Project No. **20056**

Project
**38 Chester Terrace
NW1 4ND**

Drawing Title
Proposed Second Floor Plan

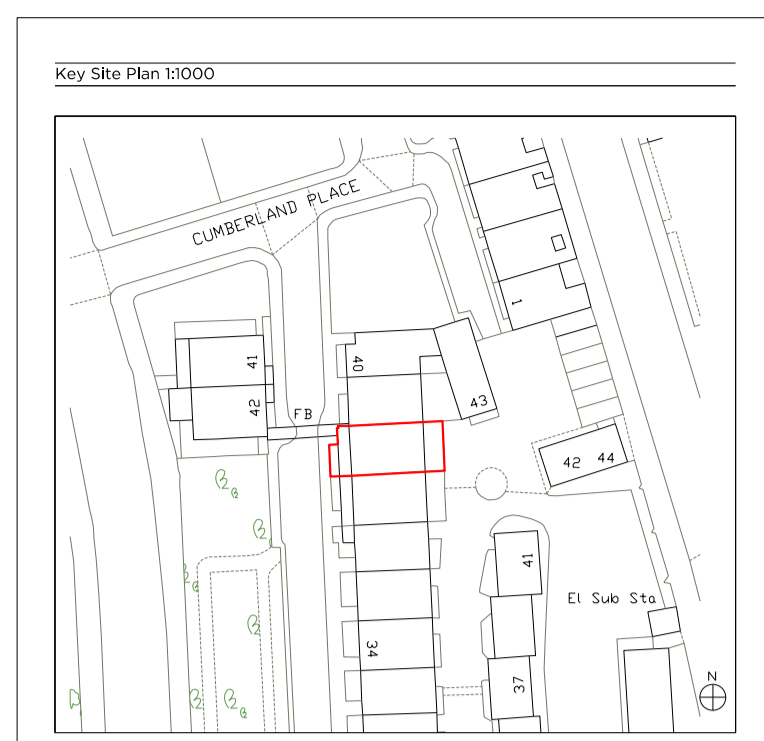
Revision Notes	
Rev. A	06.04.2021
A.1	Floor finishes in Master Bedroom and Dressing Room amended.
A.2	Room layout amended, retaining existing kitchenette arrangement.
Rev. B	03.03.2022
B.1	Door changed to a jib door.
B.2	Amendments to the bathroom vanity, radiator omitted.
B.3	Door changed to open on the opposite direction.
B.4	Amendments to the floor finishes.
